VEHICLE - WARRANTY BULLETIN

BULLETIN 2026-4 | VERSION A

CAMPAIGN N° 2025-0009 / 2026-0004

Canyon Vehicle Stability System (VSS) Calibration Update

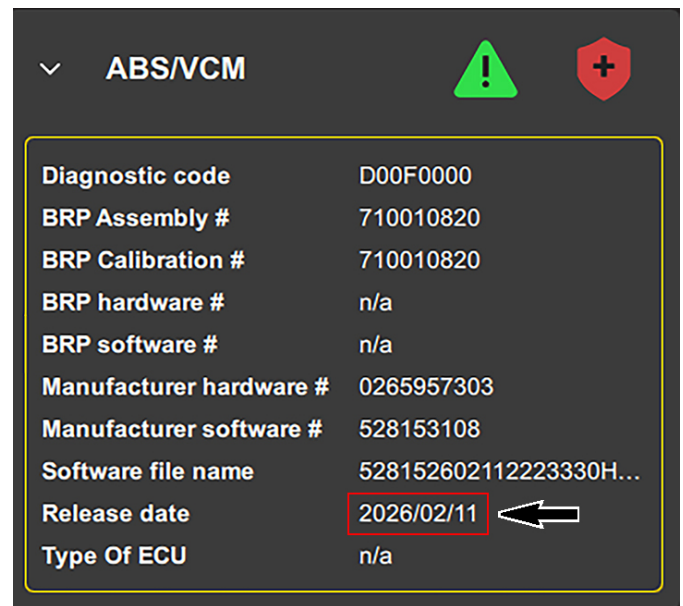
3. Select the "Vehicle Update" tab and perform the VSS Calibration Update.

Follow on-screen instructions in BUDS3.

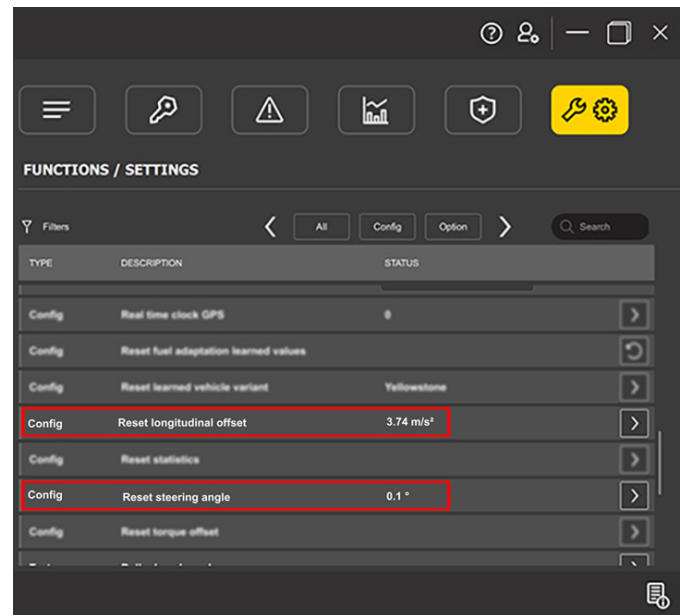
4. After closing the page, BUDS will offer a rescan (not automatic). Once the scan is performed the updated module will be removed from the list of pending updates.
5. Ensure the operation is successful for the VSS module by validating the software release date is as shown below.

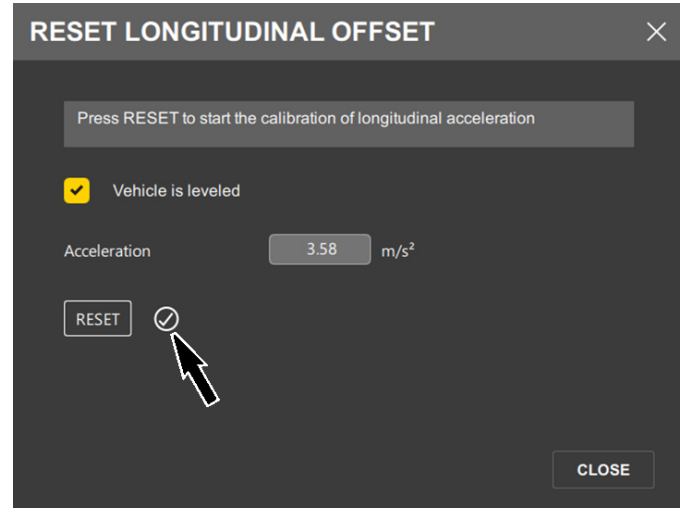
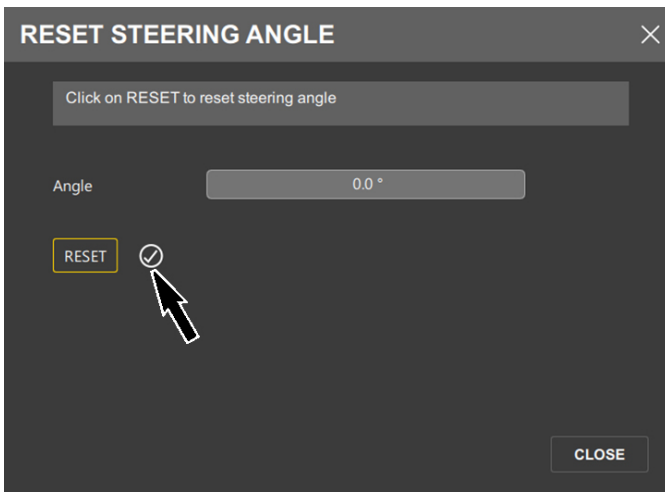
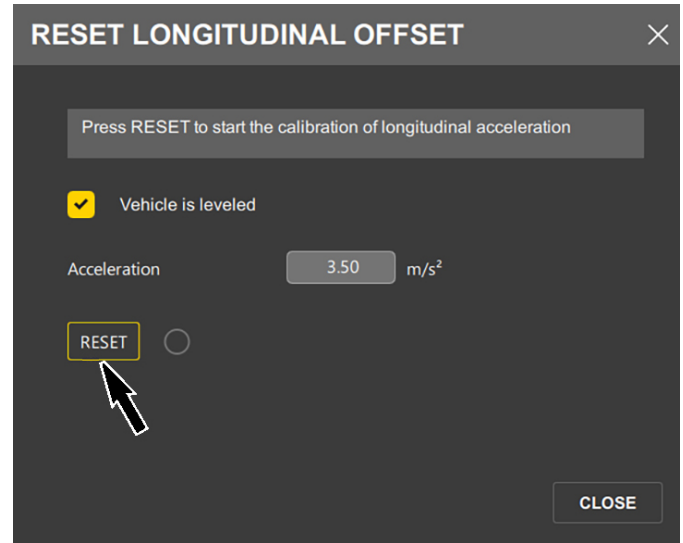
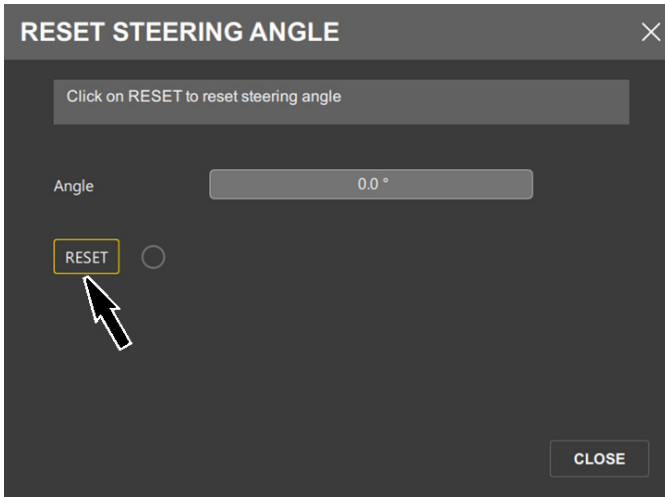
6. Once the VSS update is completed, perform the following actions.

7. Reset the SAS first.

8. Then reset longitudinal offset.

NOTE
Ensure the vehicle is set on a flat horizontal surface before proceeding.

NOTE
It is strongly advised to perform a key-off/key-on cycle between each learning procedure.
